TOLEDO - LUCAS COUNTY PLAN COMMISSIONS

REF: SUP-12003-22

SUBJECT: Amendment to a Special Use Permit Originally Granted by Ordinance 524-85, and Ordinance 852-86 for the raze and rebuild of a gas station and canopy at 950 W Alexis Rd.

LANDSCAPE PLAN

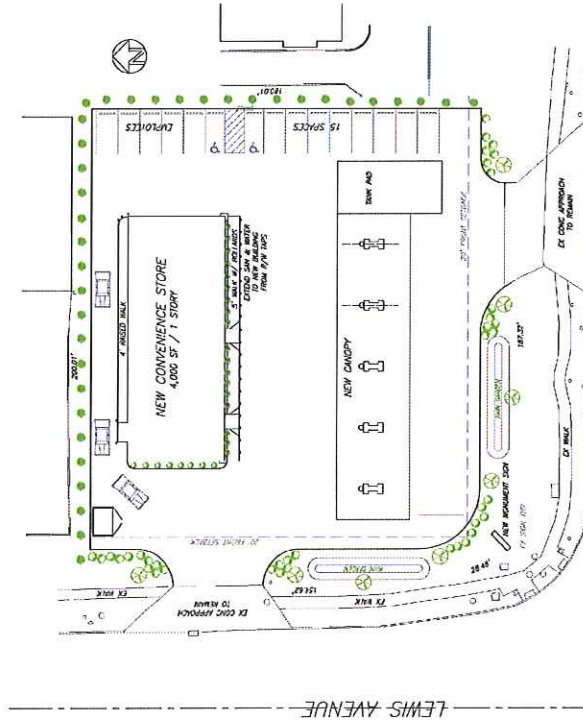
- a. A fifteen (15') foot landscape buffer along Lewis is required containing six (6) trees. **Not acceptable as depicted, additional trees required.**

- b. A fifteen (15') foot landscape buffer along Alexis is required containing seven (7) trees. **Not acceptable as depicted, additional trees required.**

- c. Perimeter landscaping is required around the parking lot to screen headlights from right of way. Additional shrubs stretching the entire length of the paved area along Lewis and Alexis are required. **Not acceptable as depicted.**

- f. Landscape islands/peninsulas are required at the end of each parking row. **None depicted, not acceptable as depicted.**
 - g. Landscape areas within the parking area must be peninsular or island types and must be constructed with six-inch (6") by eighteen-inch (18") concrete curbing, cast-in-place, extruded, or by some other process approved by the Planning Director;

- t. A detailed planting plan for the proposed rain gardens is required. The rain gardens must be planted with turf, trees, and/or perennial plant materials chosen from lists provided by the Rain Garden Initiative. The design of said rain gardens must be approved by the Department of Public Utilities. **No planting plan submitted.**
